DEPARTMENT OF TRANSPORTATION
FEDERAL AVIATION ADMINISTRATION

FAR Part 36 Compliance Regulation

FINAL ENVIRONMENTAL IMPACT STATEMENT
Pursuant to Section 102(2)(C), P.L. 91-190

Figure I-1 Noise Levels of Aircraft at FAR Part 36 Approach Measuring Point

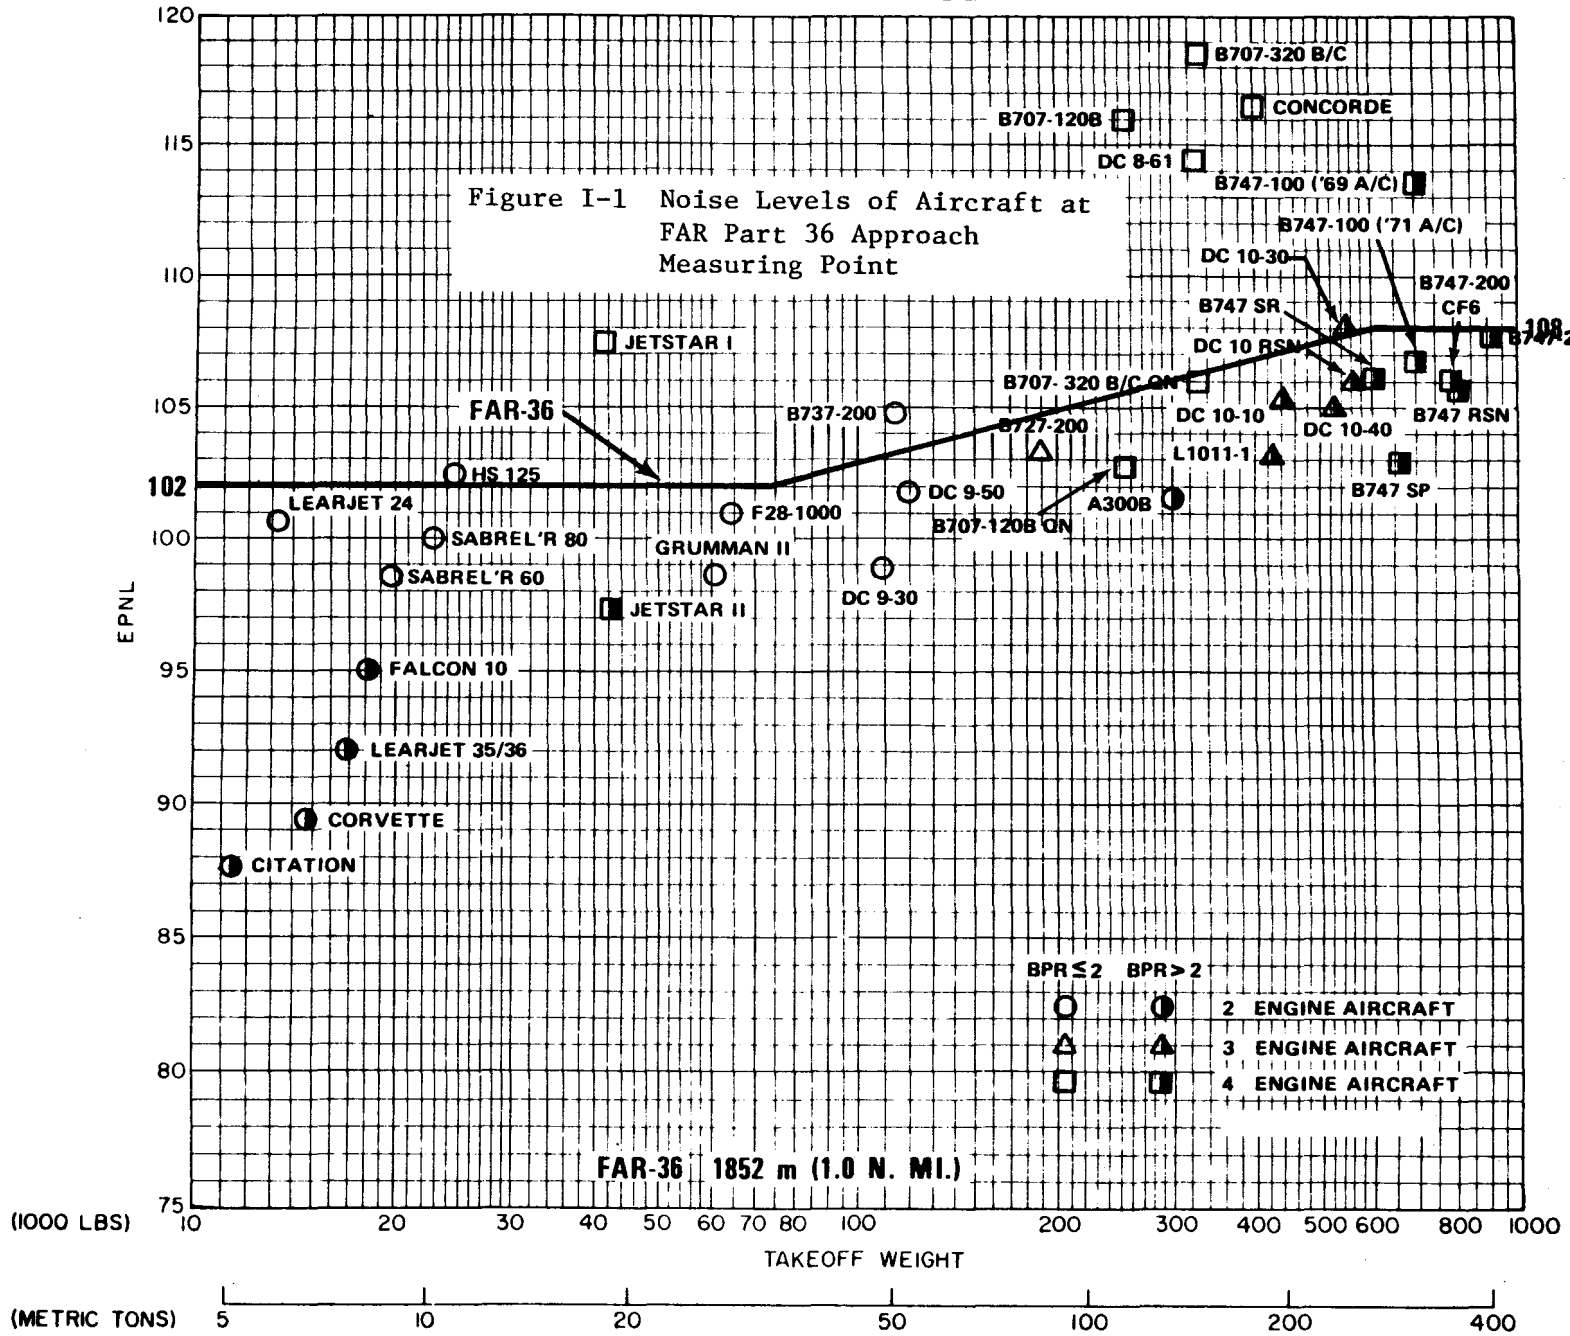
2. Page 3, third line. It is indicated here that the "open circles signify estimates" in Figure I-1. New data is available which would indicate many of the levels indicated on Figure I-1 are incorrectly high.

3. Page 3, the second sentence indicates that Figure I-1 shows that appropriate reductions to meet Part 36 noise levels are achievable. The point is that the retrofits being assumed are not technical available now for six of the basic aircraft models.

FIGURE II-1

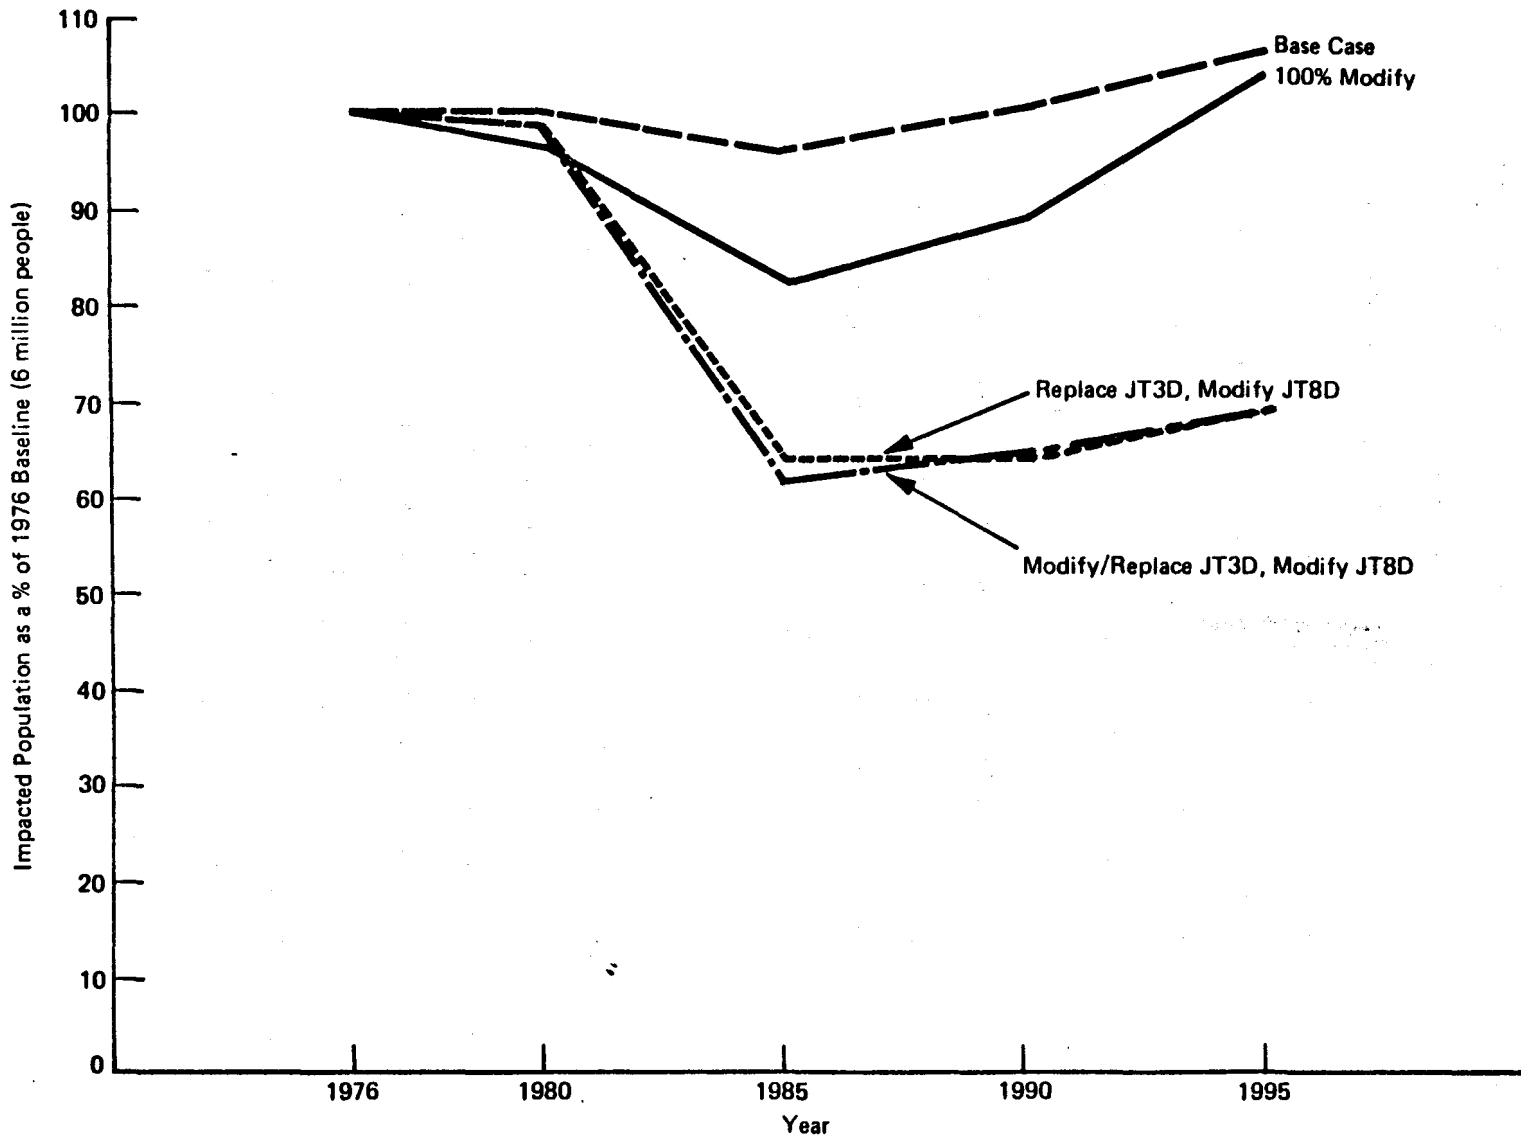
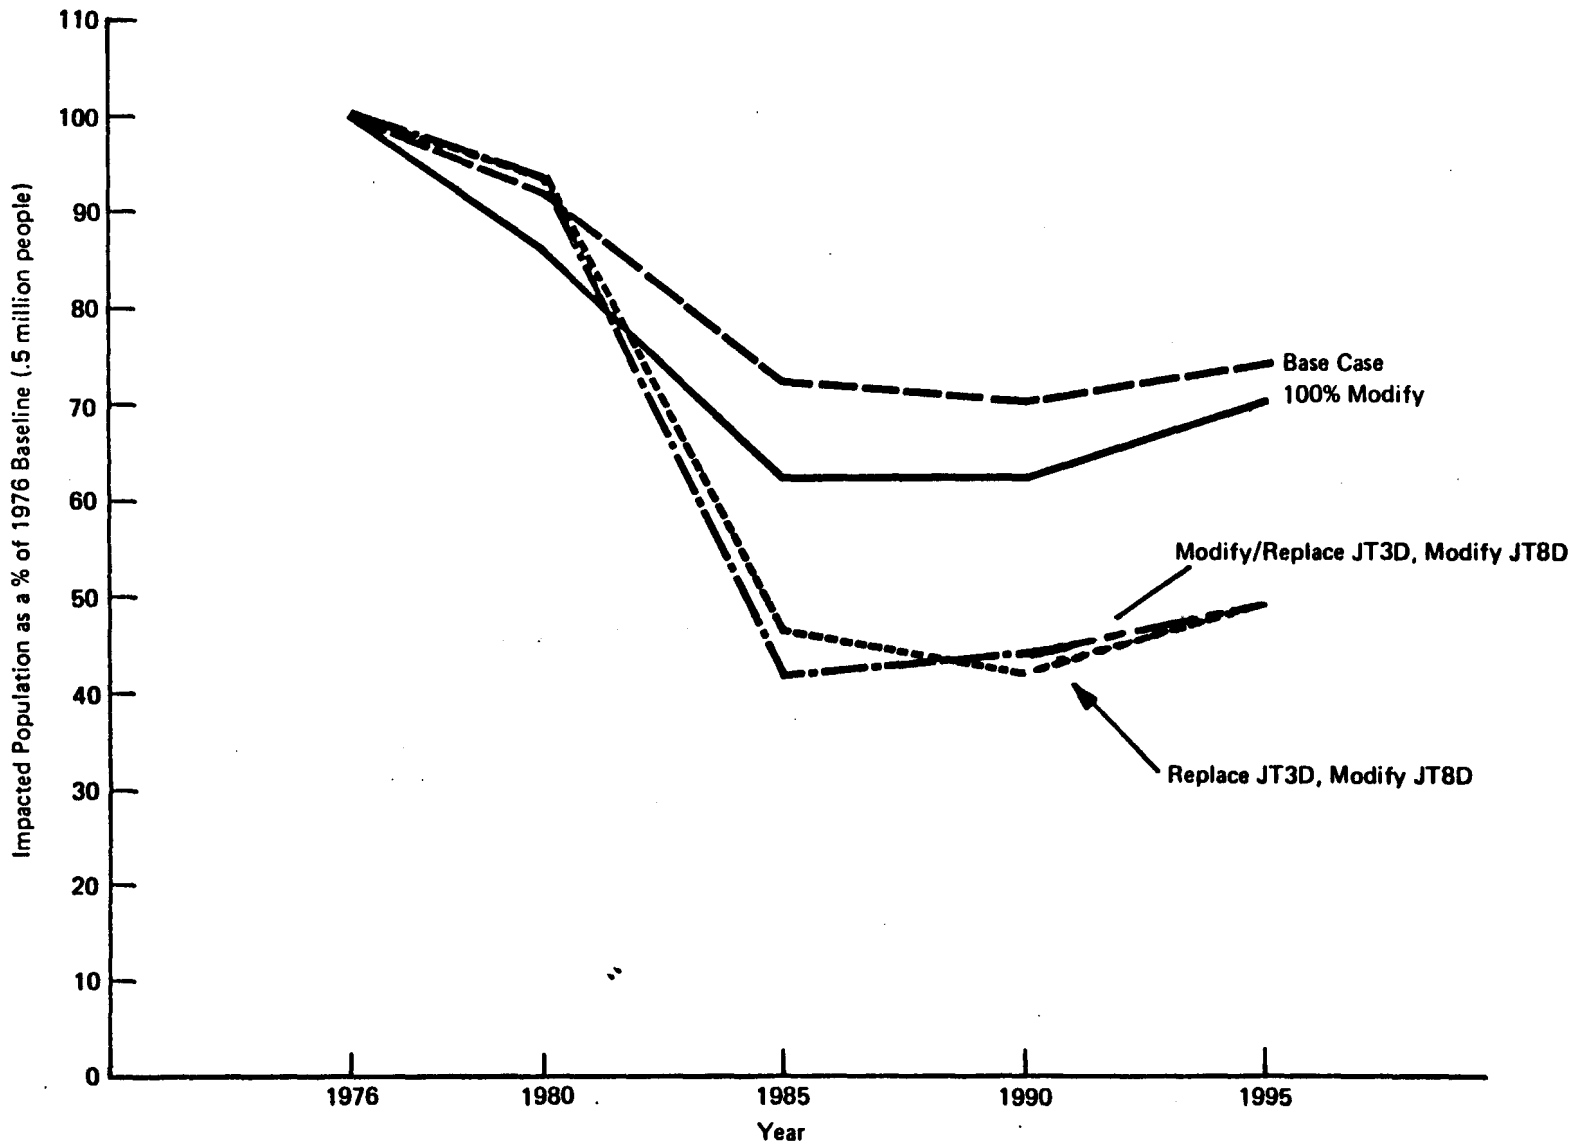
22. Page 18 and 19. It is noted that "power cutback" as permitted by FAR Part 36 provisions is used in Figures II-1 and II-2. Our comment entitled Safety is appropriate here. Noise certification
